Attachment B: Written Comments on Draft Environmental Impact Statement

A Modern LI Long Island Rail Road Expansion Project

Floral Park to Hicksylle

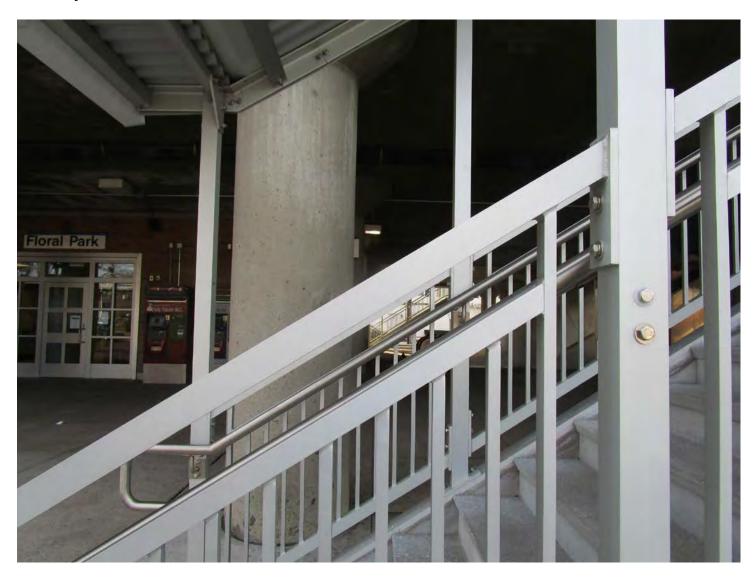
The Floral Park Station/Platform and Bellerose Station/Platform should be modernized to comply with ADA requirements; there should be no plans to eliminate the Bellerose Station.

I am submitting photos (see following pages) taken on January 14, 2017 of the poor condition of the Floral Park LIRR Station. Included are photos of the escalator, staircases and front view of where the elevator shaft is located. I recall it took over 13 months for the escalator to the elevated platform to be replaced and almost two years for new stairways to be installed. This station, as well as the Bellerose Station, are the gateway to Nassau County for the MTA LIRR and should be upgraded.

The LIRR Station was constructed and the railroad tracks were elevated in the 1960s. At the time the American with Disabilities Act was not yet law. In years past, there was an elevator at the station but it was closed down.

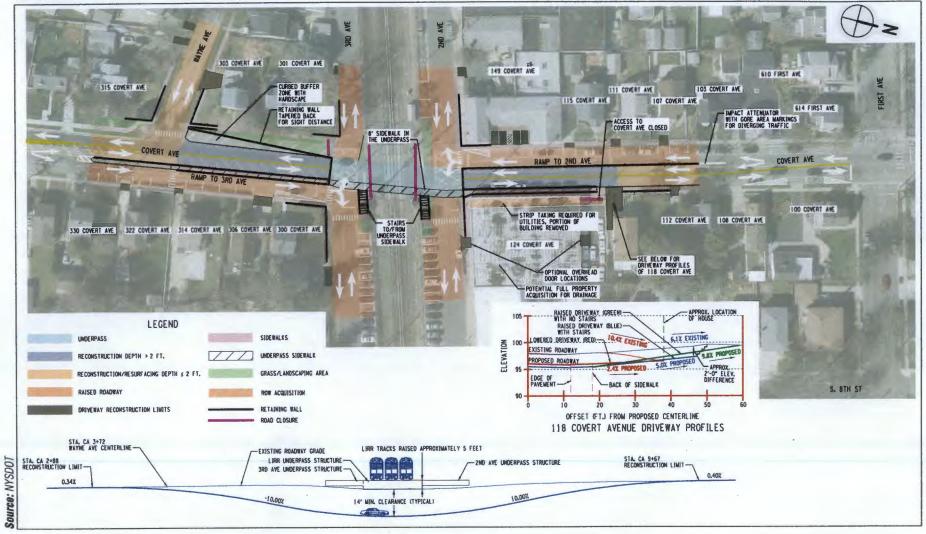
Sound attenuation walls of train wheels to rails should be incorporated into the project to lessen these soundings into the adjacent residential neighborhoods. We request sound attenuation walls of a height similar to the station platform rear walls from the New Hyde Park LIRR Station west to Covert Avenue on the south side and from the station west to South 4th Street on the north side of the tracks (Sheet 3 attached). Additionally we endorse the rebuilding of the New Hyde Park LIRR Station (Figure 1-15 attached) – using the back walls of the new platforms as sound attenuation walls.

The Greater New Hyde Park Concerned Citizens Civic Association, Inc. endorses the plan to eliminate the at-grade crossings in New Hyde Park. Specifically, we endorse the Covert Avenue - Two-Way Underpass with Sidewalk (Figure 1-19 attached); South 12th Street - Option 1: Permanent Crossing Closure with Pedestrian Bridge (Figure 1-23 attached); New Hyde Park Road – Option 1: Five-Lane Underpass with Kiss and Ride Northwest of Tracks (Figure 1-28 attached). We respectfully suggest New Hyde Park Road – the busiest of all the crossings - be eliminated first. This crossing should be completely finished before the start of Covert Avenue. The Pedestrian Bridge (Figure 1-25 attached) should be located further east toward the center of the reconstructed NHP LIRR station. Our DEIS comments.

Figure 3.1 – 115 New Hyde Park Road

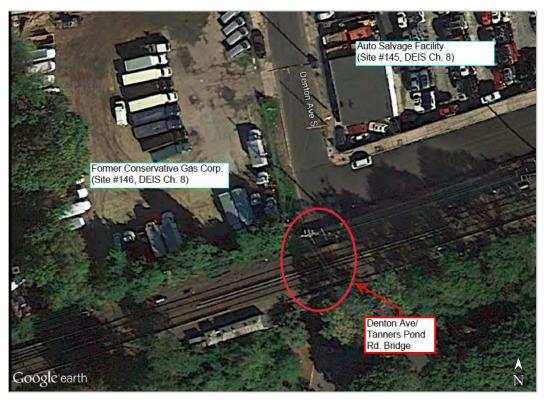
As shown on Page 169 of Appendix 1-A of the DEIS, a stormwater recharge system would be constructed within the footprint of the former metal works facility at 115 New Hyde Park Road under Option 1. The preliminary drainage design includes installing an underground recharge chamber system to either a depth of 14 or 31 feet below ground surface, depending on the specific design chosen. The Appendix 1-A Technical Memorandum states that this design is based on preliminary borings at the site but no results or boring logs are included in the DEIS. The DEIS notes that if such a recharge system could not be constructed, another alternative drainage design would connect underpass drainage into an existing Nassau County recharge basin utilizing existing Nassau County drainage systems. The existing drainage systems may require upgrades or replacement to accommodate this alternative approach to the construction of the underground recharge chamber.

If subsurface investigations performed at 115 New Hyde Park Road were to identify soil and/or groundwater impacts related to the historic metal works operations, the ability to recharge stormwater on this parcel might be limited, or not possible, depending on the type and depth of the impacts. The infiltration of stormwater to soil above the groundwater table has the potential to mobilize soil contamination to groundwater and/or exacerbate and mobilize existing groundwater contamination. In addition, the cost for the excavation and off-site disposal of potentially metalsimpacted soils (including possible characteristic hazardous wastes) to accommodate the recharge infrastructure may be higher than budgeted. If these impacts could not be addressed prior to the planned installation of the drainage system, it is likely that the alternative drainage design option of improving and connecting to existing drainage systems would be needed (Section 4 of VERTEX's report addresses concerns with this alternative drainage design). Since significant subsurface investigation of the parcel is unlikely to be implemented prior to the completion of building demolition in December 2017, it is not clear that the schedule would allow for the comprehensive evaluation of subsurface data, development of appropriate remedial plans, and the implementation of potential contingency design changes prior to the start of utility relocation activities in December 2017 and northern drainage excavation in April 2018. As noted previously, any schedule delays or design changes at this grade elimination would likely affect the start of construction on other parts of the Proposed Project, thereby extending the overall schedule of the work and increasing the period of time that residents and commercial businesses in the Village would be subject to impacts such as traffic and noise.

Figure 3.3 – Plainfield Avenue Bridge

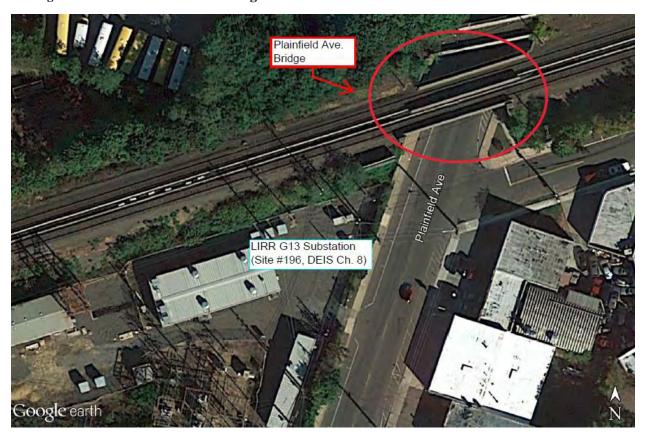
• Plainfield Avenue Bridge (Floral Park) – According to Appendix 1-A of the DEIS, an additional bridge over Plainfield Avenue will be retrofitted to accommodate the planned third track. As shown in the Appendix for Chapter 8 of the DEIS, this bridge is located immediately adjacent to site #196, which is the existing Floral Park LIRR G13 substation that is not to be altered during the construction of the Proposed Project. According to the DEIS, site #196 is the subject of subsurface releases being actively addressed by LIRR as part of the Voluntary Cleanup Program. In this case, it is likely that subsurface investigation data in the vicinity of this location associated with the Proposed Project is available for review, and the specific risks to the Village can be determined and mitigated in some manner; however, the DEIS does not include any of this data and this evaluation is therefore not provided in the DEIS. The location of the substation site in relation to the Plainfield Avenue bridge is shown on Figure 3.3.

Figure 6.2

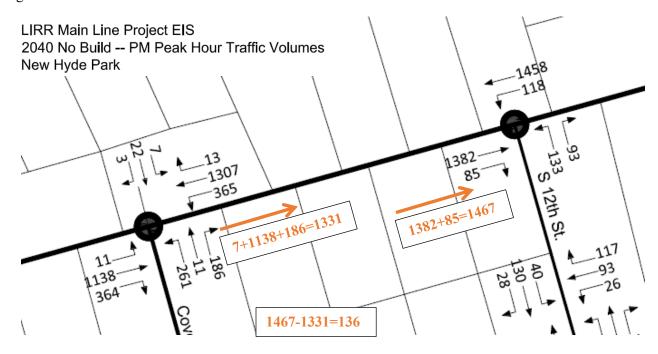
There appears to be major discrepancies in the routing of vehicles when comparing the No-Build Condition to Build Condition peak-hour volumes for the New Hyde Park volume figures (i.e., Pages 12 vs. 19 and 13 vs. 20 of Appendix 10 of the DEIS). Volumes frequently do not track between intersections with vehicles getting 'lost' between study locations. For instance, as indicated in Figure 6.2 and Figure

Photo No.: 5
Location: Intersection of
Carnation Ave and Atlantic
Ave
Direction: South

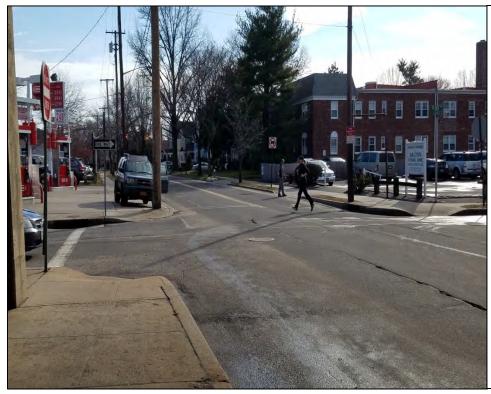
<u>Comments:</u> Non-Compliant Ramp; Missing detectable warning strip; Obstructions restrict landing.

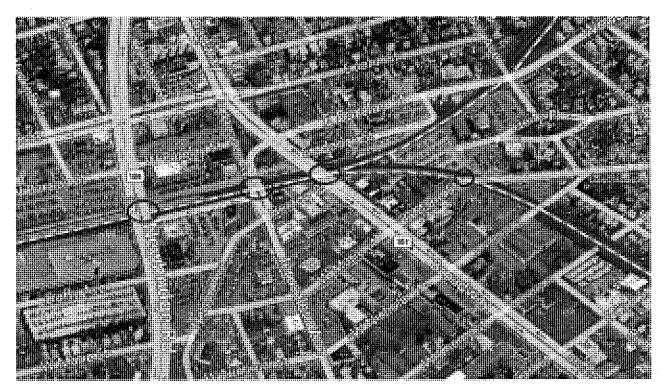
Areas requiring cleanup from pigeon droppings and nesting activity as well as additional pigeon deterrent measures.

Close the South 12th Street Public Highway-Rail At-Grade Crossing Completely to Vehicle Traffic (Figure 1-23 attached)

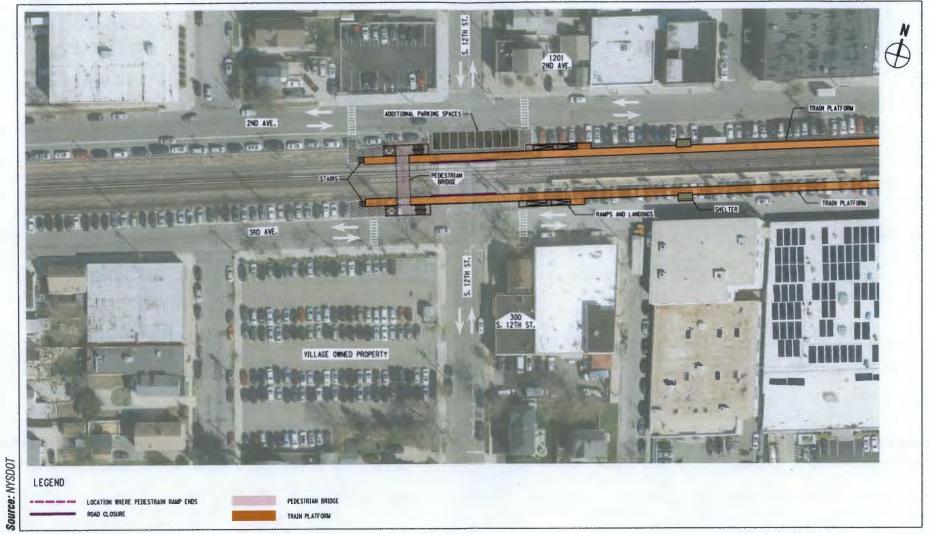
As part of the LIRR Expansion Project, the New Hyde Park Group of Public Highway-Rail At-Grade Crossings of New Hyde Park Road, Covert Avenue and South 12th Street are to be eliminated. The LIRR currently proposes that New Hyde Park Road and Covert Avenue be depressed under the railway. The LIRR currently indicates that the South 12th Street Public Highway-Rail At-Grade Crossing may be eliminated similarly to New Hyde Park Road and Covert Avenue or it may be closed completely to vehicle traffic.

The South 12th Street Public Highway-Rail At-Grade Crossing should be closed completely to vehicular traffic (Option 1). This course of action has several advantages, including a savings of \$100 million of taxpayer dollars and an overall reduction in the project construction timeframe. The LIRR currently proposes that the New Hyde Park Railroad Station platforms be extended westward, with the platforms crossing over South 12th Street to accommodate M-3, M-7 and M-9 trains that are twelve (12) railroad cars long. The 2nd and 3rd Avenue vehicle and pedestrian infrastructure design will be enhanced by eliminating the South 12th Street At-Grade Crossing bottleneck in the middle of the New Hyde Park railroad station hub. The Pedestrian Bridge (Figure 1-15) above the railroad will be located near the western end of a reconstructed New Hyde Park Railroad Station.

Close the South 12th Street Public Highway-Rail At-Grade Crossing Completely to Vehicle Traffic (Figure 1-23 attached)

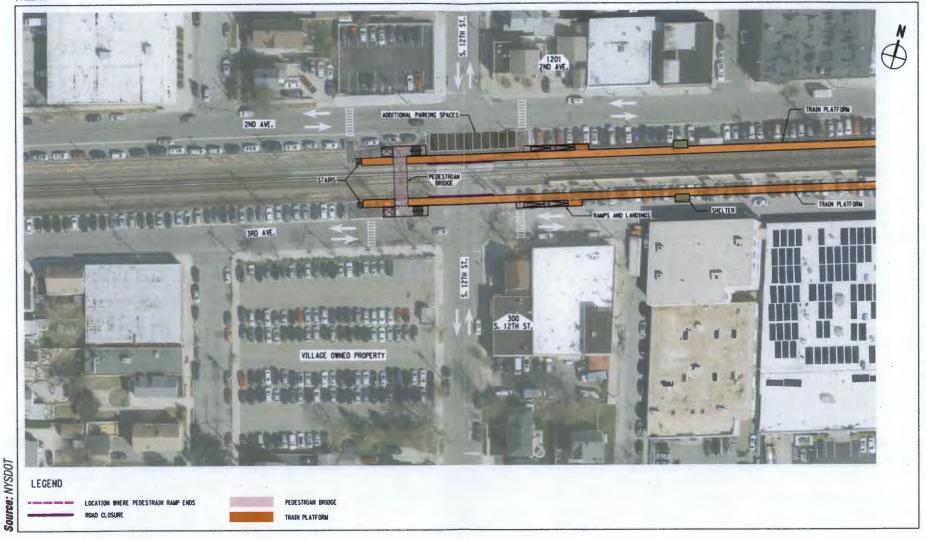
As part of the LIRR Expansion Project, the New Hyde Park Group of Public Highway-Rail At-Grade Crossings of New Hyde Park Road, Covert Avenue and South 12th Street are to be eliminated. The LIRR currently proposes that New Hyde Park Road and Covert Avenue be depressed under the railway. The LIRR currently indicates that the South 12th Street Public Highway-Rail At-Grade Crossing may be eliminated similarly to New Hyde Park Road and Covert Avenue or it may be closed completely to vehicle traffic.

The South 12th Street Public Highway-Rail At-Grade Crossing should be closed completely to vehicular traffic (Option 1). This course of action has several advantages, including a savings of \$100 million of taxpayer dollars and an overall reduction in the project construction timeframe. The LIRR currently proposes that the New Hyde Park Railroad Station platforms be extended westward, with the platforms crossing over South 12th Street to accommodate M-3, M-7 and M-9 trains that are twelve (12) railroad cars long. The 2nd and 3rd Avenue vehicle and pedestrian infrastructure design will be enhanced by eliminating the South 12th Street At-Grade Crossing bottleneck in the middle of the New Hyde Park railroad station hub. The Pedestrian Bridge (Figure 1-15) above the railroad will be located near the western end of a reconstructed New Hyde Park Railroad Station.
